**BOARD OF ZONING ADJUSTMENT
441 4th STREET N.W., SUITE 200S
WASHINGTON, DC 20011**

BZA No. 19067

APPELLANT’S SUPPLEMENTAL STATEMENT IN SUPPORT OF APPEAL

HOUSE RENOVATION
AND ADDITION
1117 ALLISON STREET N.W.

A3

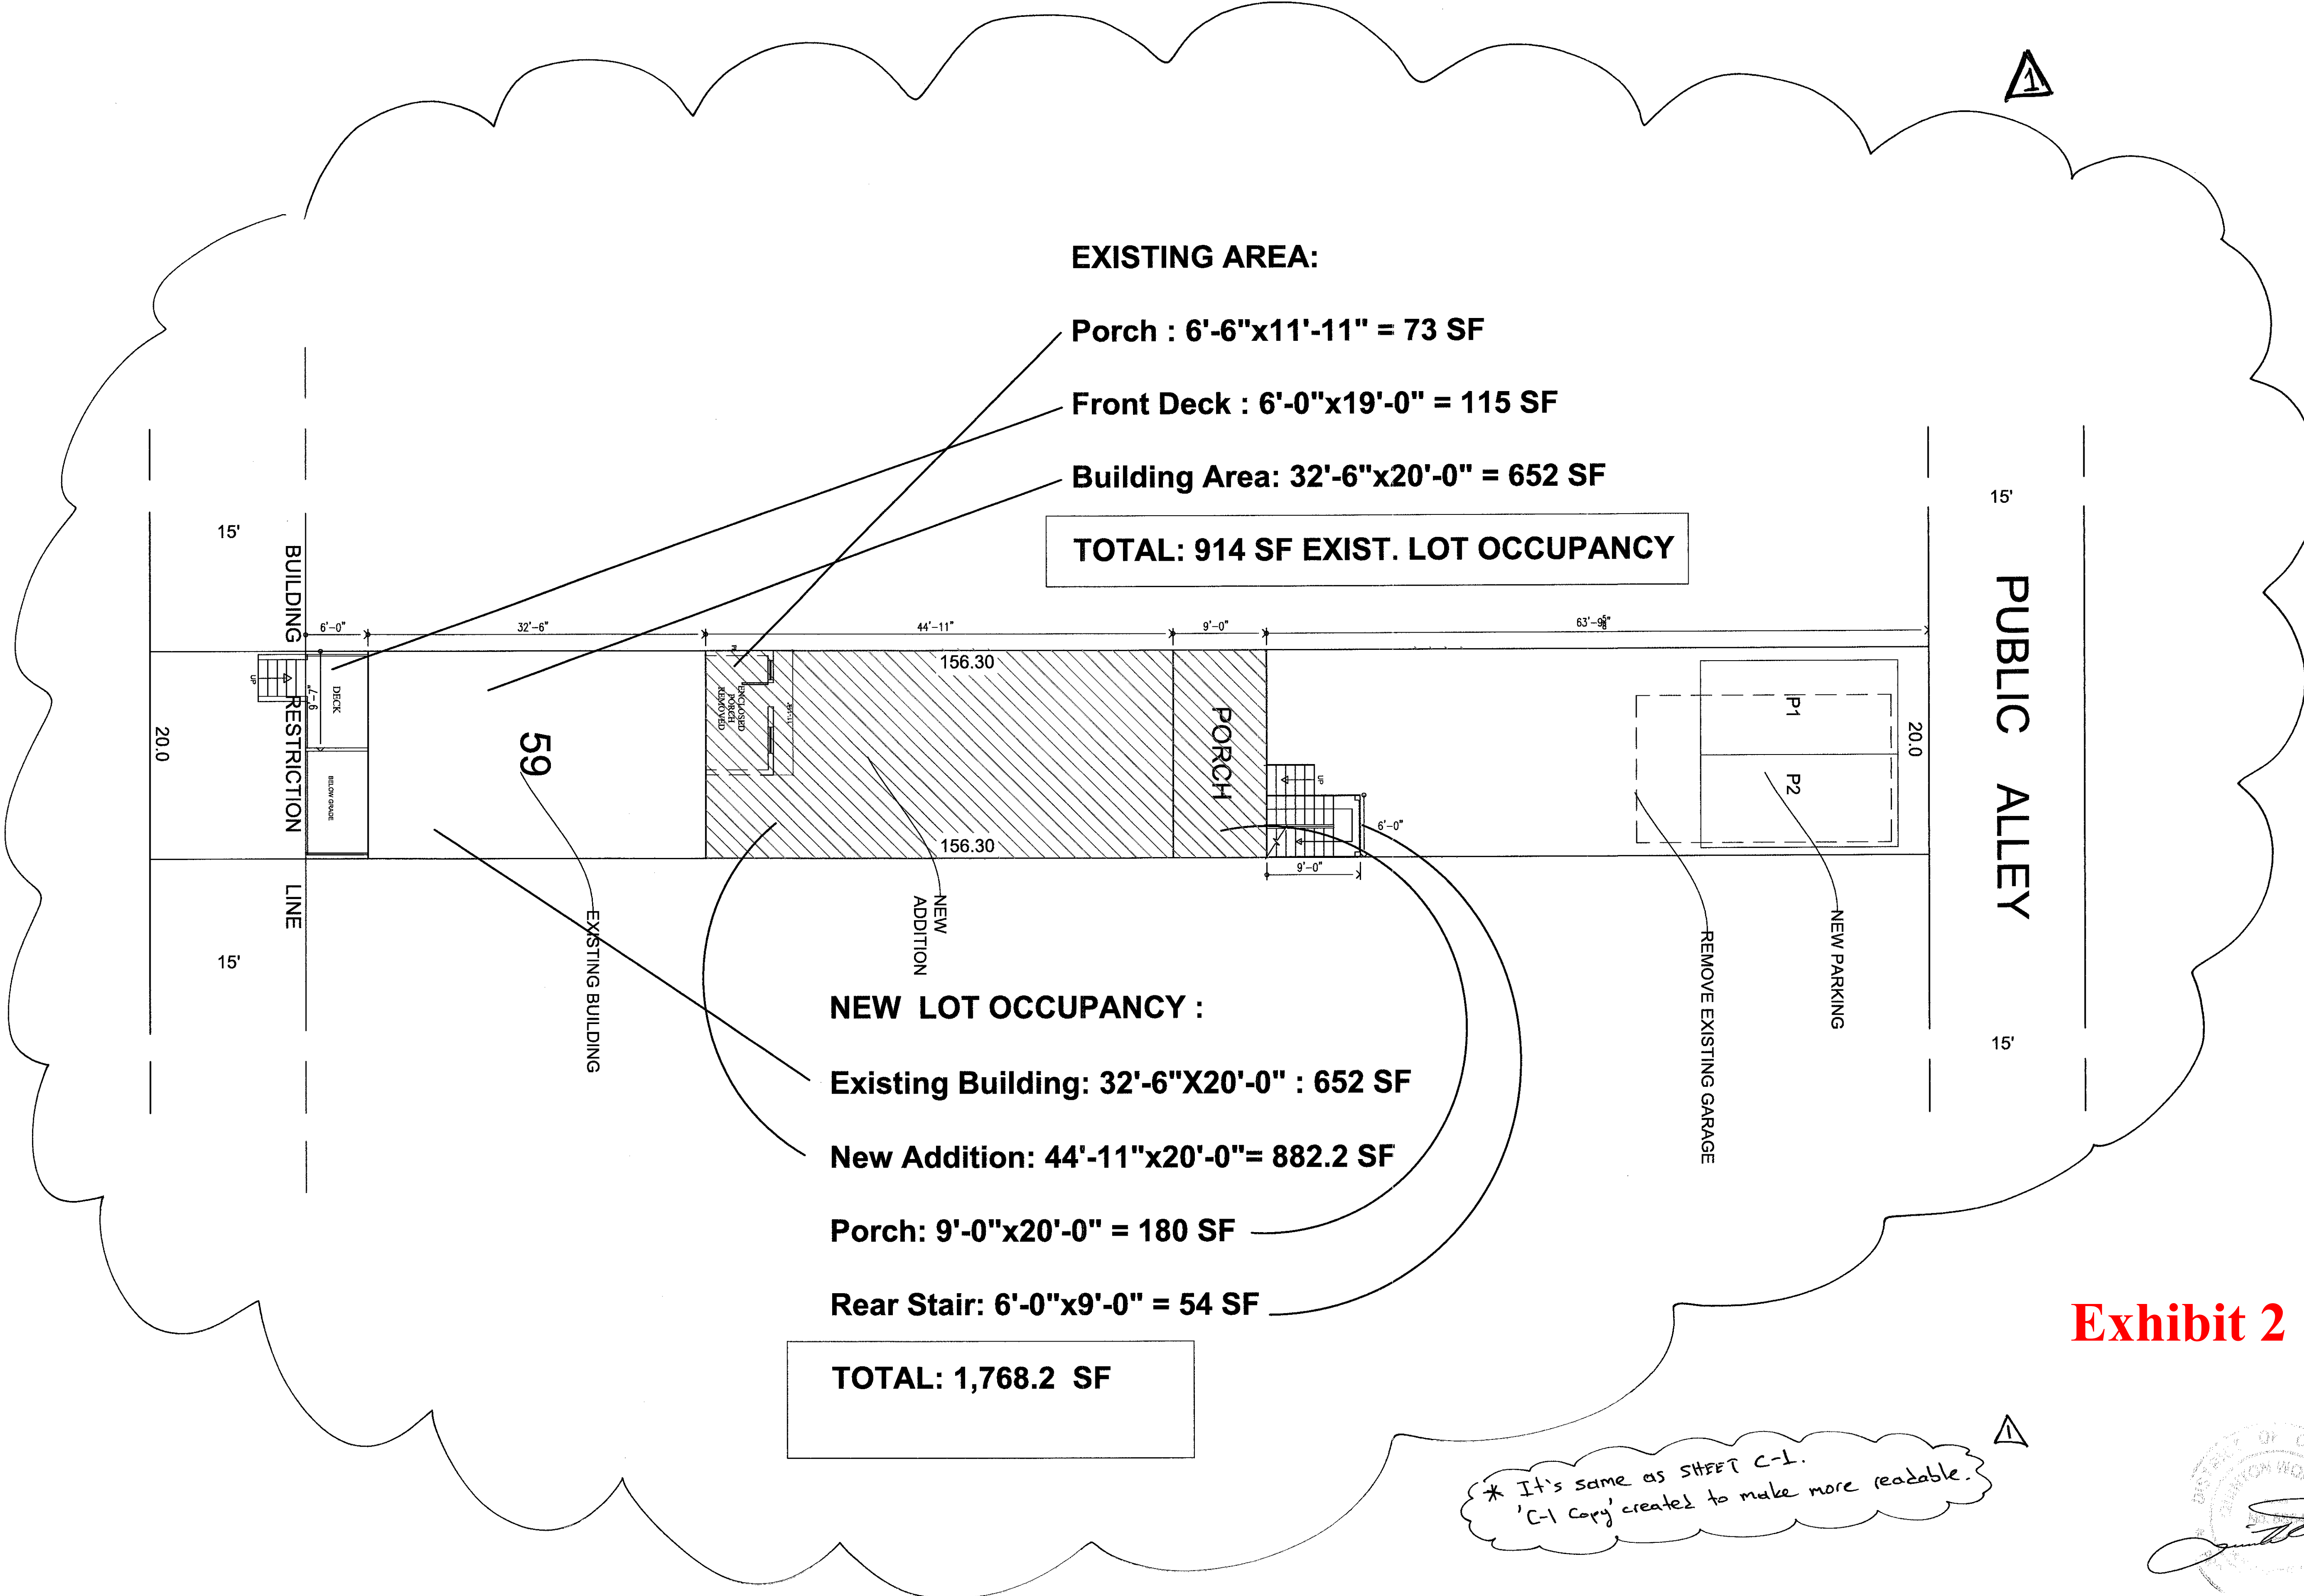
For example, the Revised Plans now indicate that the front porch will be removed. *See* Exhibits 1 and 2. However, the plans for the May Permit approved on May 27, 2015, show that the existing front porch will remain and not change. *See* Exhibits 3, 4, and 5. In addition, the front porch is included in the proposed lot area coverage of 1933 sq ft for the May Permit. *See* Exhibits 5 and 6. The front porch is not included in the proposed lot area coverage and percentage of lot occupancy in the Revised Plans. *See* Exhibit 7.

front porch will be removed. *See* Exhibits 3, 4 and 5. Both Sheets A3 and C1 of the May Permit building plans clearly depict that the front porch is part of the new building. This is a material and substantive change in the building plans requiring an amendment to the May Permit.

In contrast, the building plans for the May Permit are explicit about other parts of the building that will be removed. For example, the notation on the same Sheet A3 for the May Permit shows that the exterior walls on the rear porch will be removed. *See* Exhibit 3. Likewise, the notation on Sheet C1 for the May Permit shows that the garage will be removed. *See* Exhibit 5. Neither of these sheets indicates that the front porch will be demolished.

PEER REVIEW NOTE #3: In the revised Permit Set drawings (October 2015), Sheet A3 indicates that the front porch is to be demolished. However, on the previous Sheet A3 in the approved permit B1505734 (May 2015), the front porch was shown as existing to remain. Since, the previous Sheet A3 did not show the front porch as being removed but the new Sheet A3 does, this is essentially a material change in the revised Permit Set drawings (October 2015). Also, the existing front porch is in actuality at least 8 FT deep, not 6 FT as shown on Sheet A3.

C1

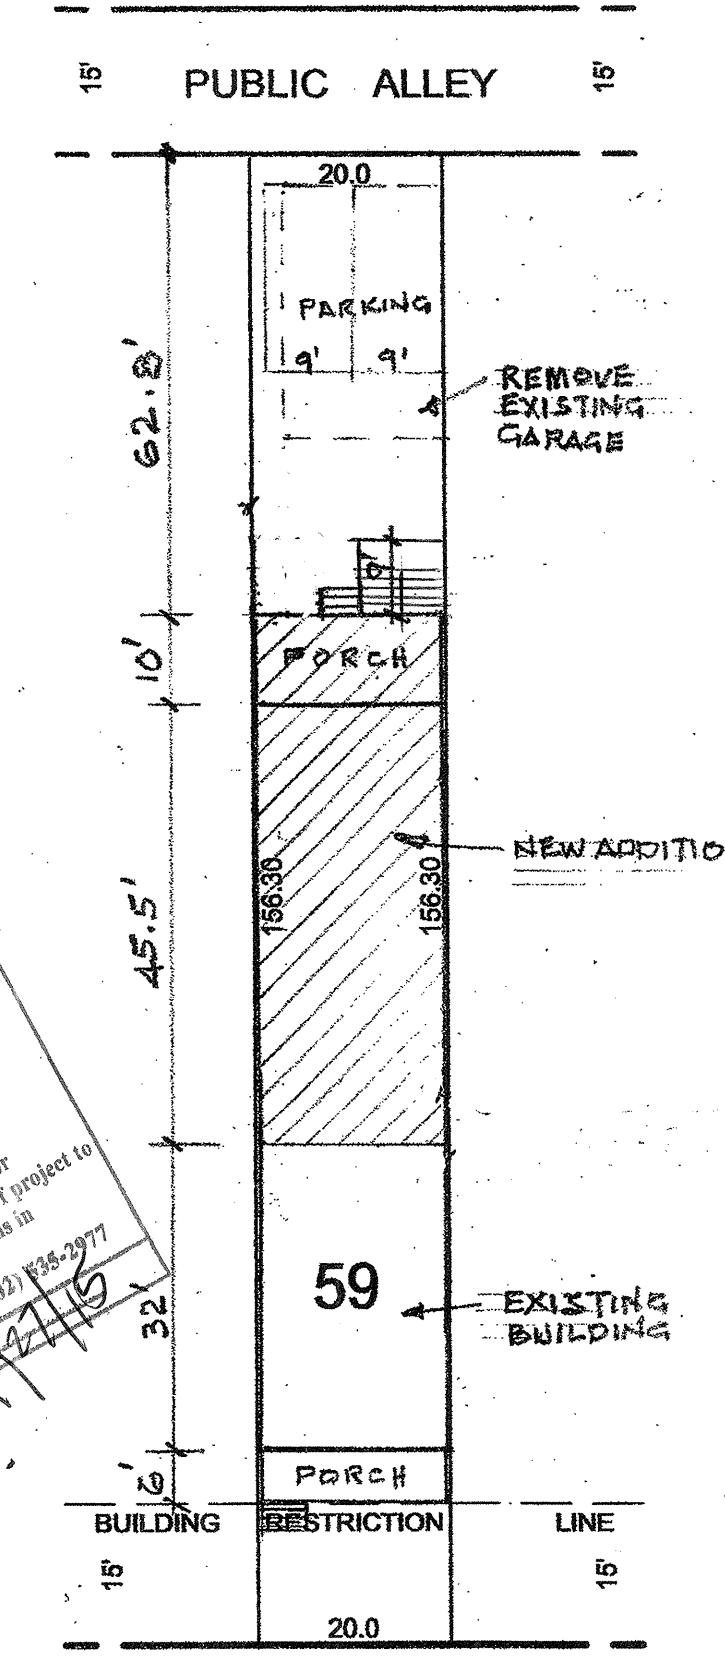
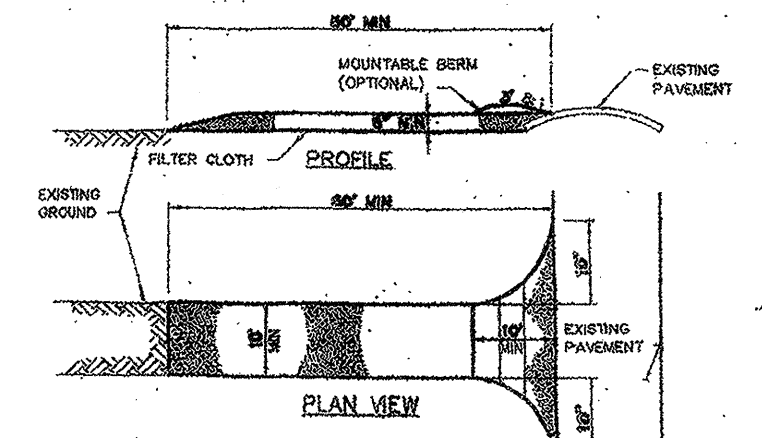
Sheets A1, A4 and C1 of the May Permit building plans contain significant errors and inconsistencies regarding the dimensions of the proposed apartment building and the percentage of lot occupancy. *See* Exhibit 12, pp. 3-5, 7-8. Revised Sheets A1 and C1 show that the proposed lot coverage for the apartment building is 1933 sq ft, which results in a calculated lot occupancy of 61.8 percent. *See* Exhibits 5 and 6. However, using the information and dimensions provided on Revised Sheet A4 of the proposed first floor plan results in a calculated lot occupancy of 58.67 percent. *See* Exhibit 4. Finally, using the same dimensions provided on Revised Sheet C1 results in a calculated lot occupancy of 61.57 percent. *See* Exhibit 5.

As is discussed further below, because the building plans inaccurately represent the dimensions of the front porch, the proposed lot area coverage is greater than what is indicated on Sheets A1, A4 and C1 of the May Permit building plans. Using the correct measurements of the front porch and the dimensions in the May Permit building plan, the calculated lot occupancy from Revised Sheets A4 and C1 are 59.82 percent and 62.70 percent, respectively. *See Exhibit 12, pp. 3-4, 7-8.*

PEER REVIEW NOTE #1: The existing lot area is 3126 square feet. However, there are significant ambiguities and dimensional errors in the Plat on Revised Sheets C1 and Proposed First Floor Plan on A4 of the May 2015 permit drawings. If you add the dimensions shown on Revised Sheet C1 that indicate the total length of the “Existing Building”, “New Addition” and “Porch”, it calculates to 87.5 feet. However, if you add the same dimensions shown on Sheet A4, it calculates to 83 feet. Additionally, the individual dimensions for those areas are different between Revised Sheet C1 and A4. Furthermore, the existing front porch is, in actuality, at least 8 feet deep, not 6 feet as shown on these sheets. Therefore, separate calculations were done for each sheet.

In the May 2015 Permit Set drawings, the information derived from and/or provided in the Plat on Revised Sheet C1 results in a calculated lot occupancy (which includes the primary structure, covered rear deck, covered rear stairway, covered front porch and covered side atrium) of 1960 square feet or 62.70 percent of the lot area.

PEER REVIEW NOTE #4: In the previous Zoning & Building Code Peer Review Report dated April 27, 2015, dimension errors were identified on the Plat associated with the approved permit B1505734 (May 2015). Adjustments were needed regarding the 15 FT Building Reservation Line setback. The Plat drawings indicated on Sheets C1 and C1-Copy in the revised Permit Set drawings (October

2015) continue to have dimension errors. The 63 FT 9 5/8 inch dimension shown at the rear of the lot is not correct and should instead be 49.3 FT.
